# Inspection Report

**Property Address:**  
1945 W Butterfly Lane  
Chicago IL

# I. Domicile Consulting Report

A. Item 7(Picture) Caulking Recommended

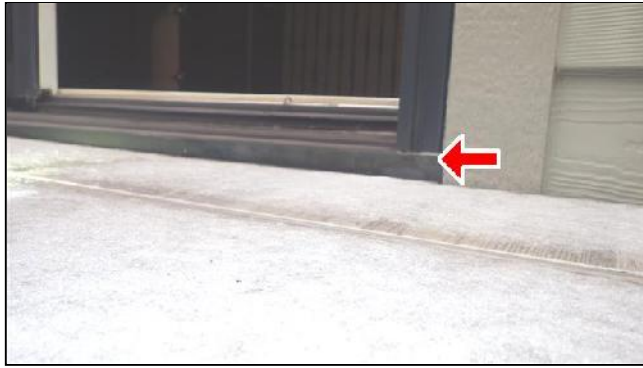
(3) Caulking is recommended at the top and sides of the exterior electrical lighting fixtures in order to prevent moisture penetration into the home and/or moisture contact with energized electrical equipment.

A. Item 9(Picture) Missing Sill Pan Flashing

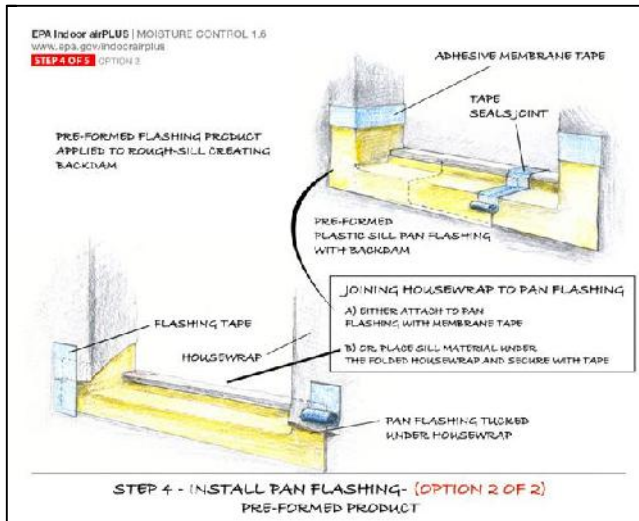
(5) This exterior door has been installed without the benefit of sill pan flashing. This greatly increases the risk for moisture intrusion and damage at this critical location. It is recommended that the door be removed and that the door opening be protected from moisture intrusion by the application of the appropriate sill pan flashing, head flashing, weather resistant barrier, flashing tape, etc. Repair by a qualified contractor is recommended.

F. Item 3(Picture) Labels Recommended

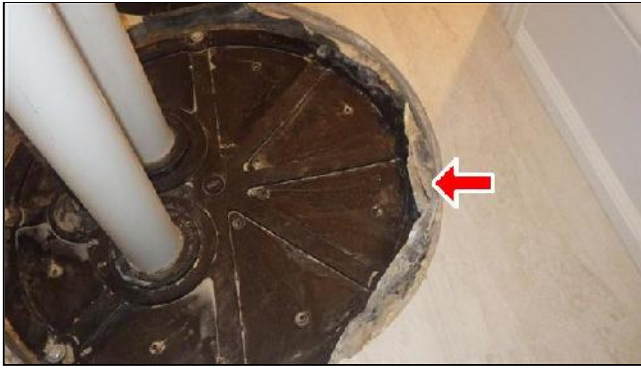
(2) All of the plumbing supply valves and gas valves in the home should be clearly labeled as to their function and areas they serve so that they may be used for emergencies, maintenance, and repairs.

F. Item 4(Picture) Cast-Iron Floor Drain

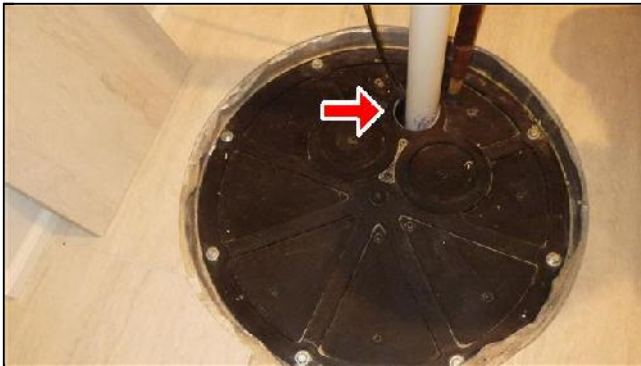
(3) It is recommended that the jagged edges of the cast-iron basement floor drain be ground smooth and made flush with the adjacent concrete slab.

G. Item 6(Picture) Integrated Controls Recommended

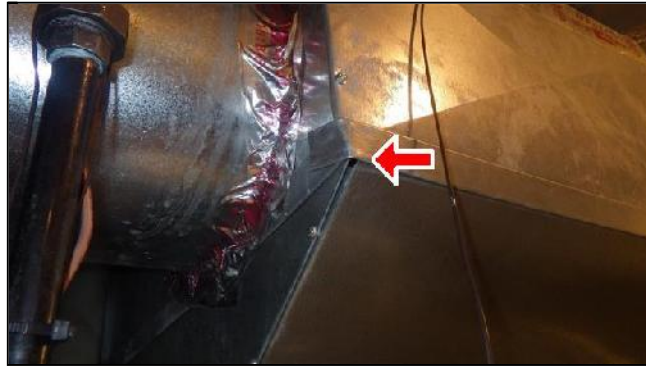
(4) The humidistat control would ideally be placed next to the thermostat control. It's placement in the furnace closet presents an 'out of sight, out of mind' situation for the homeowner. The humidistat requires frequent adjustment during the heating season. Therefore, it is recommended that the humidistat be relocated next to the thermostat.

H. Item 2(Picture) No Roof Ventilation Found

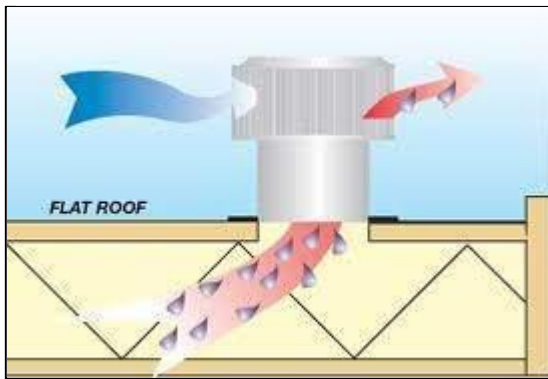
(1) The failure to provide ventilation at low slope roof assemblies, a.k.a. flat roofs, can result in wintertime condensation, wood rot, mold growth, etc. It is recommended that high-performance flat roof ventilation be installed by a qualified roofing contractor unless the seller can provide documentation that inappropriately designed and implemented unvented attic assembly is present.

H. Item 3(Picture) Missing Insulation Data

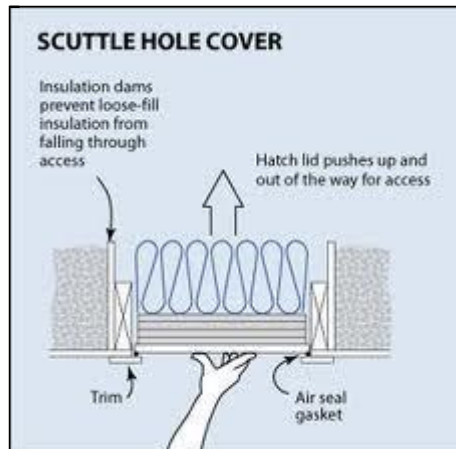
(2) The international energy conservation code requires that the type, amount, and performance value of the thermal insulation throughout the home be stated in a label attached to the electrical panel. In addition, other energy information is required at this location including window performance data. It is strongly recommended that the seller provide proof that the requirements of the existing energy conservation code have been complied with.

J. Item 4(Picture) Interior Trim Damage

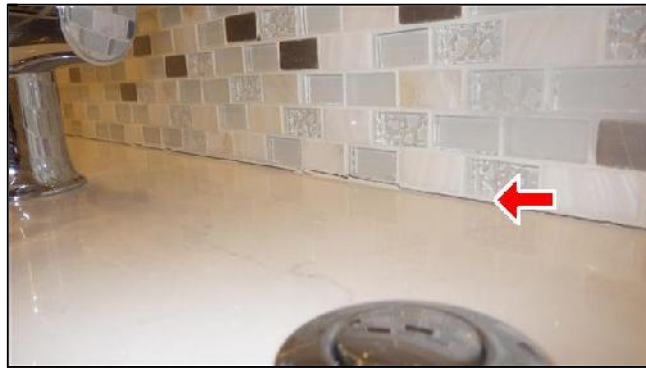
(3) The wall-to-wall carpet installers appear to have caused damage to interior finishes in multiple areas. A qualified contractor should make the necessary repairs.

K. Item 1(Picture) Risk for Wall Damage

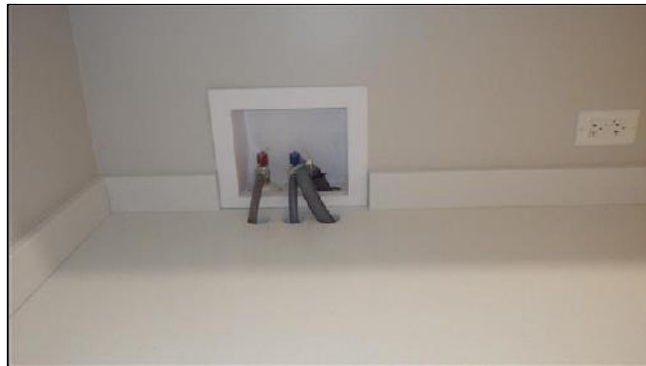
(1) The doorstops did not appear to be appropriate or adequate. It may be advisable to install more robust doorstops or to add a second doorstop.

K. Item 4(Picture) Front Entry Door

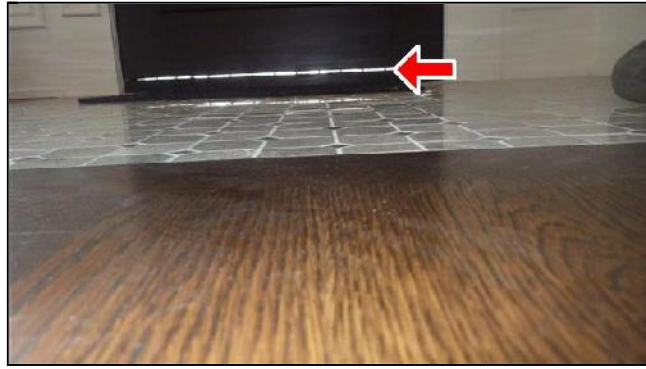
(3) The front entry door should be repaired to stop drafts and energy losses.

L. Item 6(Picture) Washing Machine Drip Pan

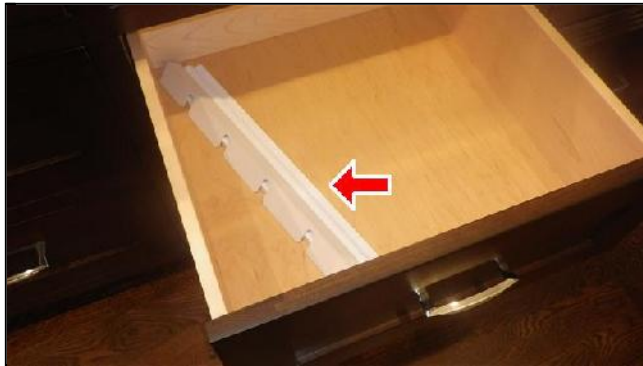
(3) The installation of a preformed drip pan is recommended underneath the washing machine in order to reduce the risk for leaking and damage in the event of an appliance malfunction.
